CITY OF ALBUQUERQUE

RE: **Lot 26 Block 5, Unit 5, S.A.D. 227**
Volcano Cliffs Subdivision
8016 Victoria NW
Grading and Drainage Plan
Engineers Stamp Date: 12/4/18 (E10D055)
Pad Certification Date: 6/5/19

MARTINEZ, ADRIAN (BUILDER: MICHAEL SANCHEZ) - G & D PLAN

RE: **Lot 26 Block 5, S.A.D. 227**
Unser Cliffs Subdivision
8016 Victoria Dr. NW
Grading and Drainage Plan
Engineers Stamp Date; 12-4-18 (E10D055)
Pad Certification Date; No Date

PAD CERTIFICATE

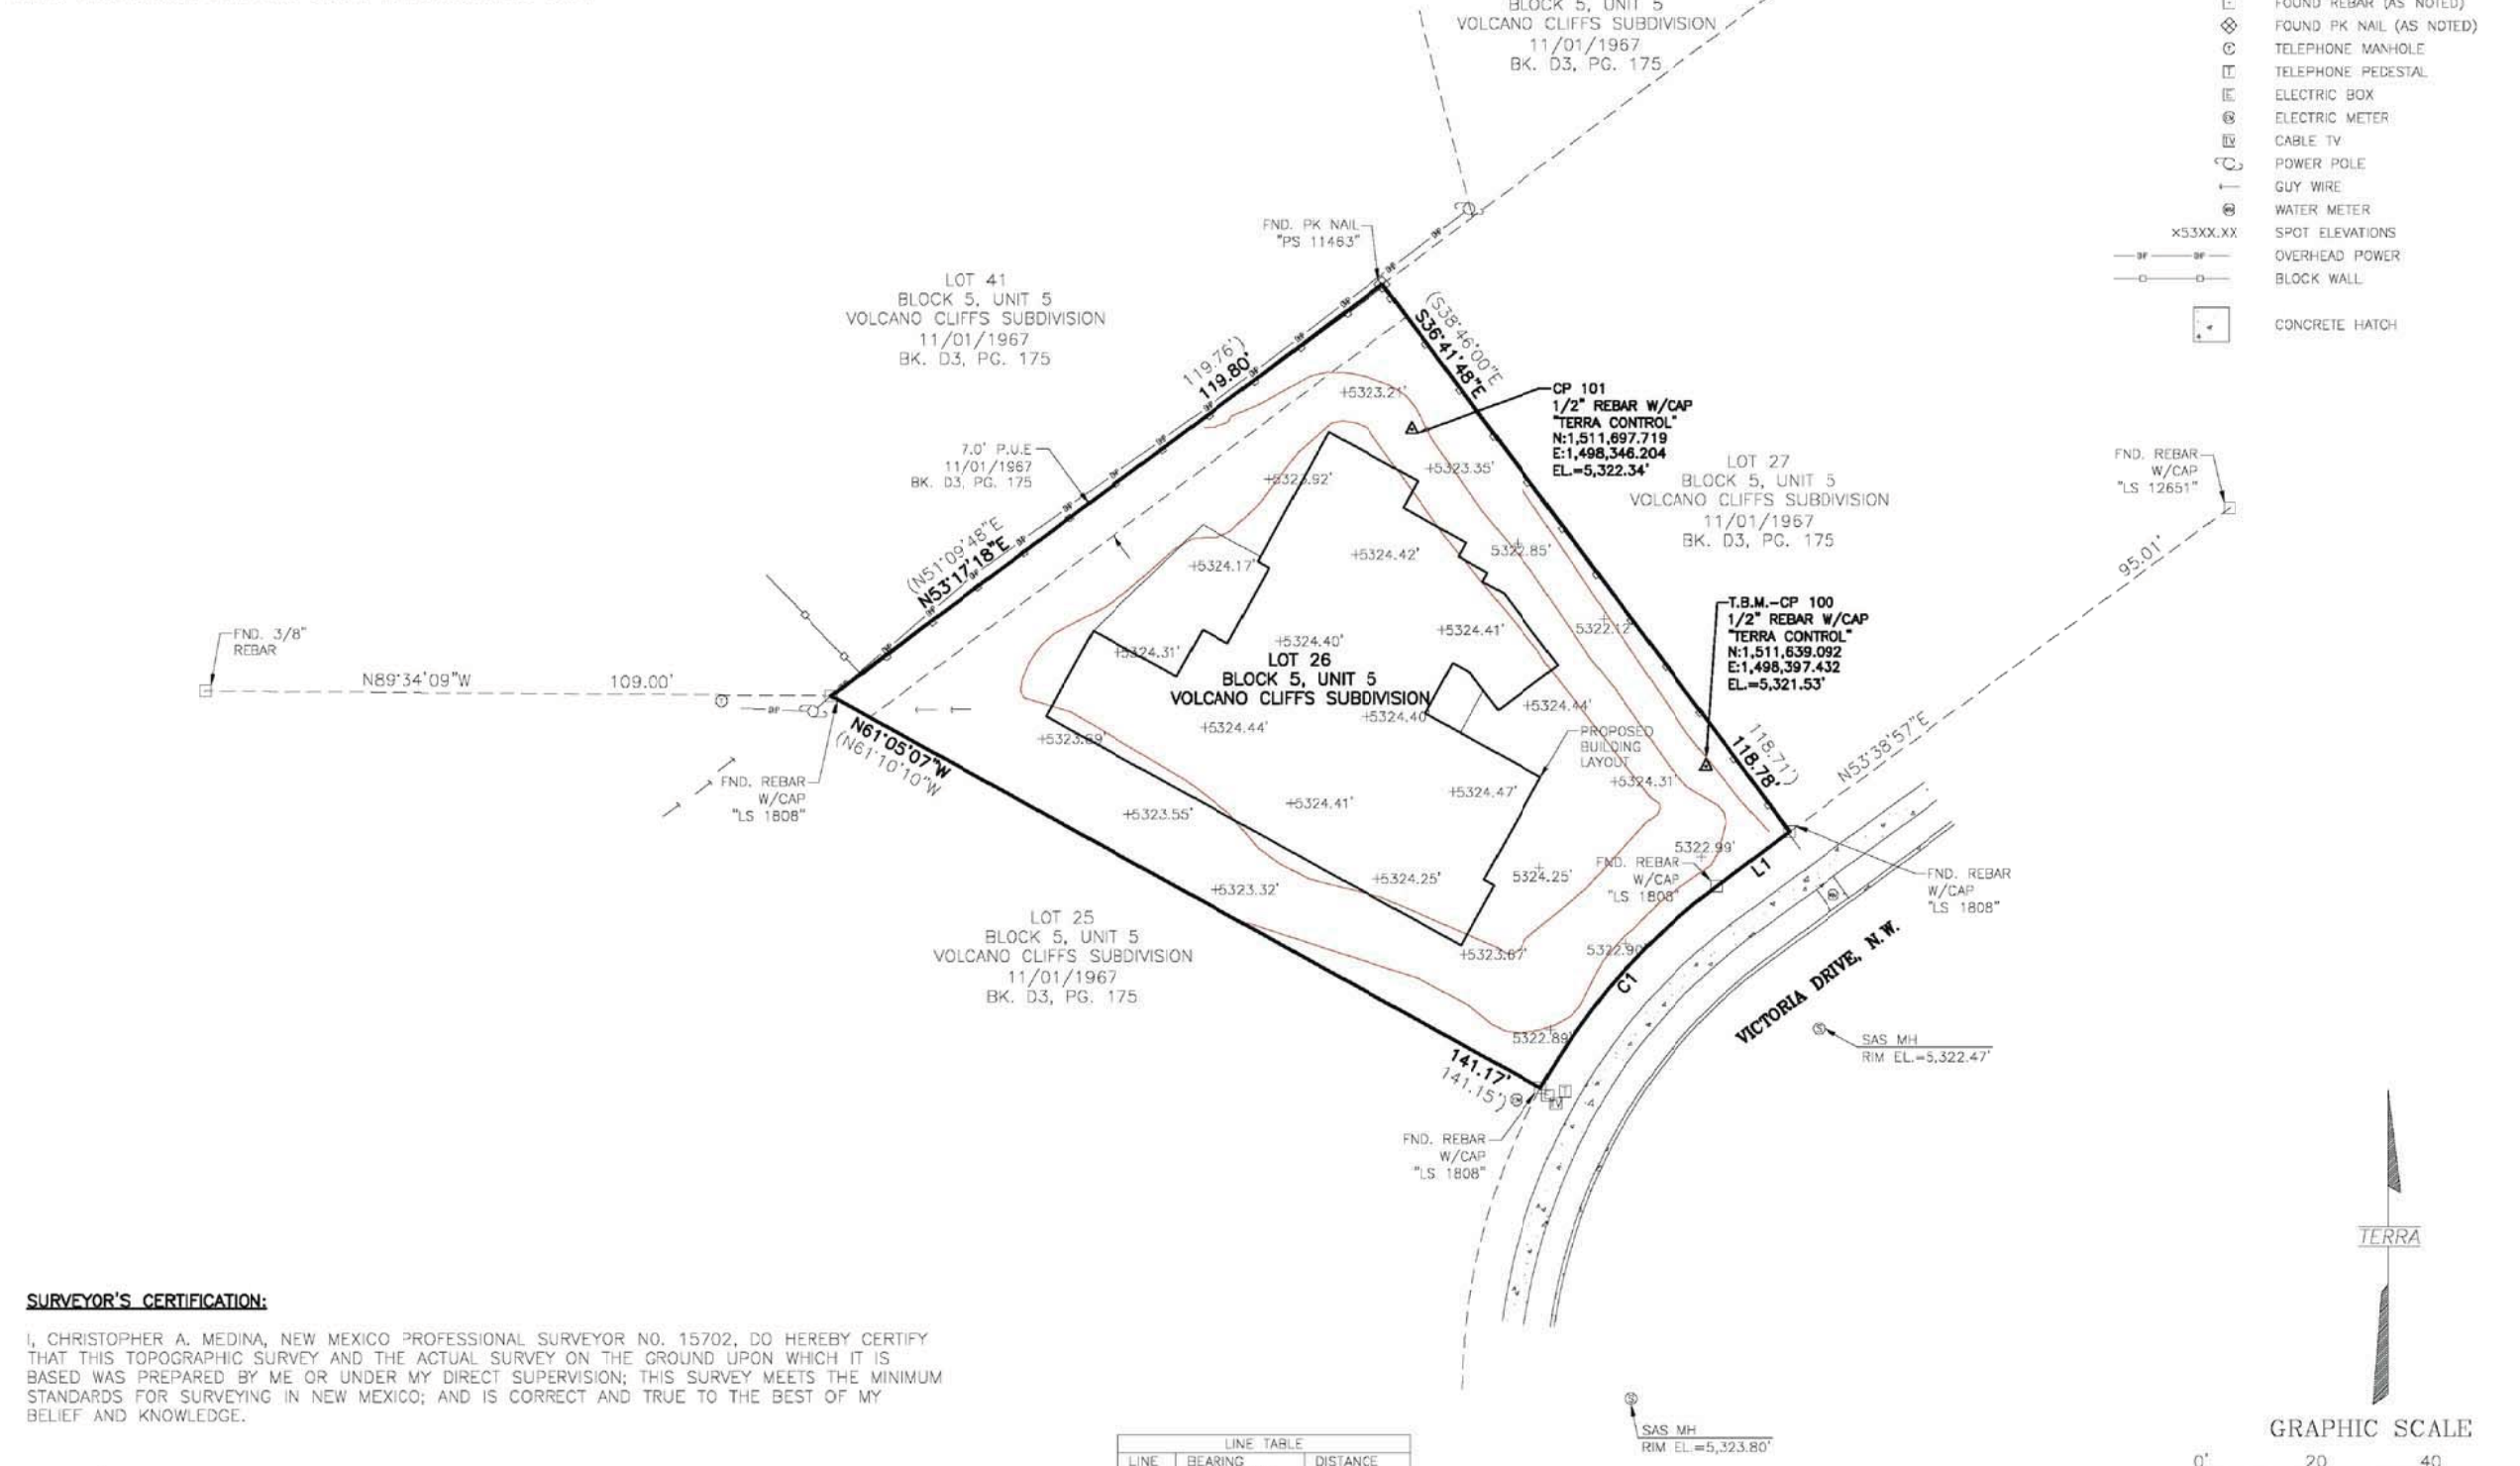
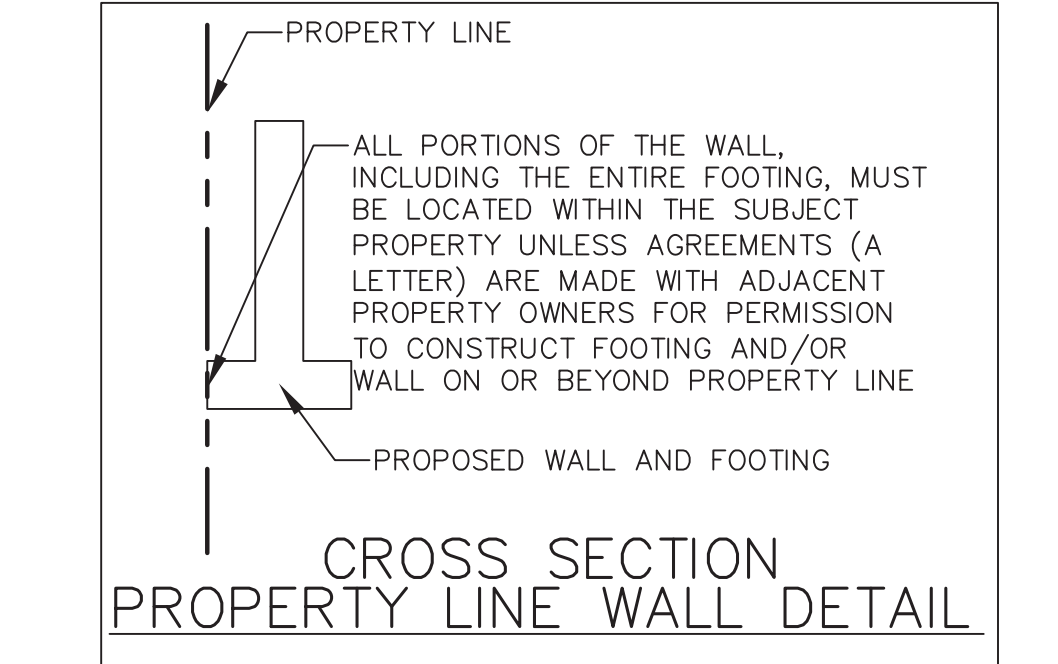
Based upon the information provided in your submittal received 6/14/19, this plan cannot be approved for Pad Certification until the following comments are addressed.

- A date must be provided along with signature in the pad cert box. **On submittal form?**
- Remove all dirt and debris from the street and sidewalk. **Owner will complete.**
- A pad is not visible, trenches have been dug in the pad for plumbing and footings, once the pad is visible resubmit for pad certification. **Owner will complete.**

6-10-19
PAD CERTIFICATION
THE SITE HAS BEEN GRADED IN
SUBSTANTIAL COMPLIANCE WITH
THE APPROVED PLAN
